UNITED STATES PATENT AND TRADEMARK OFFICE

10/671,554

Office Action Summary	Application No. 10/671,554	Applicant(s) PETERSEN, THOMAS D.	
	Examiner JAMES L. SWIGER	Art Unit 3775

DETAILED ACTION

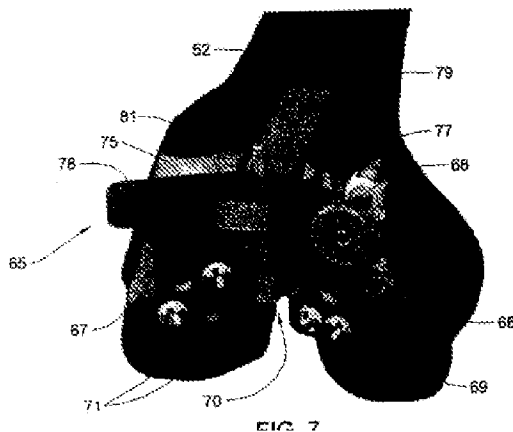
New corrected drawings in compliance with 37 CFR 1.121(d) are required in this application because the drawings submitted on 9/29/2003 are of unacceptable quality for examination. Critical areas appear to be completely shaded out, or are black. For example:

All drawings are of similar quality.

Applicant is advised to employ the services of a competent patent draftsman outside the Office, as the U.S. Patent and Trademark Office no longer prepares new drawings. The corrected drawings are required in reply to the Office action to avoid
